Access Compliance Report

Public Rights-of-Way

(Curb Ramps)

Intersection ID: 10021322	Main Street: BLAKENEY GREENS BV	Cross Street: N/A	Location: SW
ADA ID: A1EF822C5E64	Ramp Type: PerpDiag	Initial Pass/Fail: Fail	Overall Compliance: No
		Severity Score: 12.5

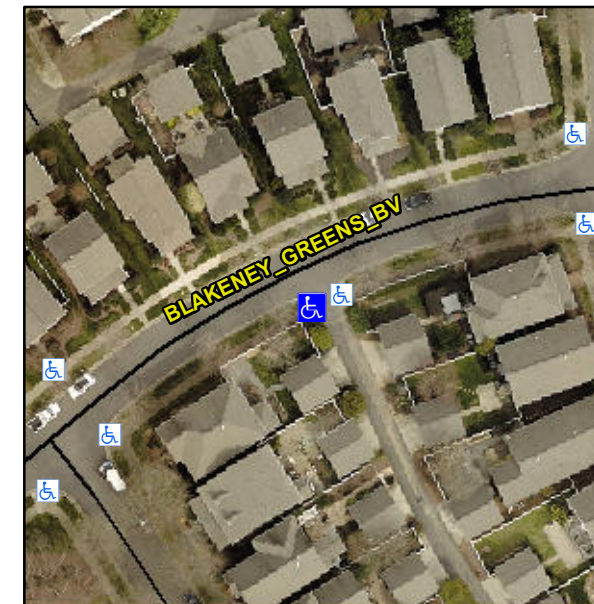
R304.2.2

Compliance	Description	Data	Compliance	Description	Data
N/A	Ramp Length (in)	79.0	No	Ramp Slope (%)	8.6
Yes	Ramp Width (in)	60.0	Yes	Ramp XSlope (%)	0.6
N/A	Flare Type LT	N/A	N/A	Flare Type RT	N/A
N/A	Flare Slope LT (%)	N/A	N/A	Flare Slope RT (%)	N/A
N/A	Flare Traversable LT?	N/A	N/A	Flare Traversable RT?	N/A
N/A	Landing Length (in)	N/A	N/A	DWS Provided?	N/A
N/A	Landing Width (in)	N/A	N/A	DWS Contrast?	N/A
N/A	Landing Slope (%)	N/A	N/A	DWS Length (in)	N/A
N/A	Landing X Slope (%)	N/A	N/A	DWS Full Width?	N/A
N/A	Landing Curb? (Y/N)	N/A	N/A	DWS Offset (in)	N/A
N/A	Shared Landing?	N/A			
N/A	Gutter Ponding?	N/A	N/A	Gutter Slope (%)	N/A
N/A	Gutter Lip Ht (in)	N/A	N/A	Gutter X Slope (%)	N/A
N/A	Painted X Walk1?	No	N/A	Painted X Walk2?	No
	X Walk 1 Direction	To NE		X Walk 2 Direction	To N
N/A	X Walk 1 Width (in)	N/A	N/A	X Walk 2 Width (in)	N/A
	X Walk 1 Slope (%)	1.6		X Walk 2 Slope (%)	1.5
	X Walk 1 X Slope (%)	1.4		X Walk 2 X Slope (%)	2.0

Remove & Replace Curb Ramp With Two New Directional Ramps or Equivalent.
